REMARKS**A. Drawings:**

AMENDMENTS TO THE DRAWINGS

FIG. 1

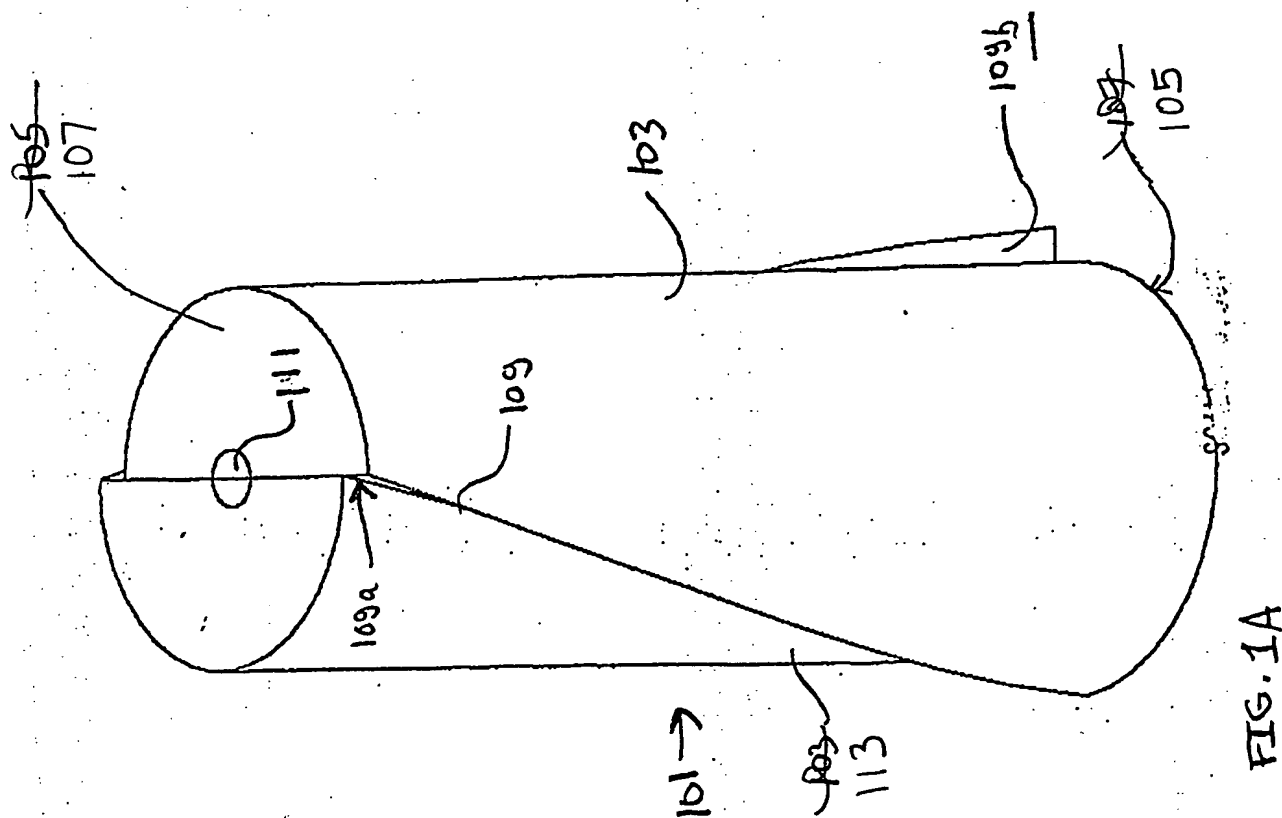
Original FIG. 1B has been replaced by a formal drawing. The formal drawing of FIG 1B also corrects the original drawing with respect to top surface and bottom surface. The top surface is “107” and the bottom surface is “105”. No new matter was added.

Original FIG 1A has been replaced by a formal drawing. The formal drawing of FIG 1A has been changed to reflect the cylindrical shape of the pile section. No new matter was added.

FIG. 2

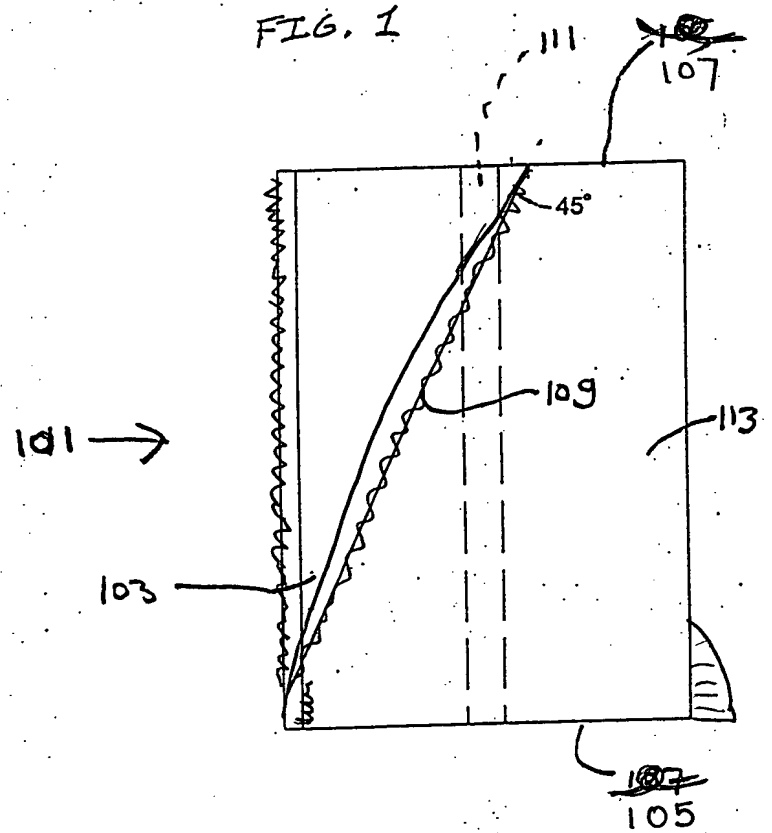
Original FIG 2 has been replaced by a formal drawing. The formal drawing of FIG 2 more accurately depicts the bottom view of the pile of FIG 1B. The offset faces, which would be visible from the bottom view, were not shown in original FIG 2. No new matter was added.

FIG. 3

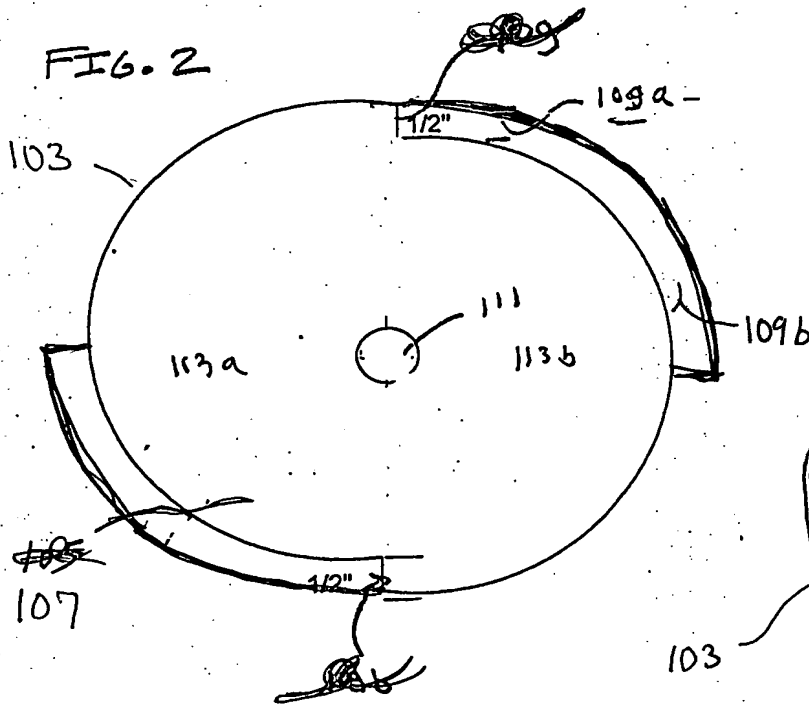
Original FIG 3 has been replaced by a formal drawing. The formal drawing of FIG 3 has been changed to correct the orientation of the offset faces 109. No new matter was added.
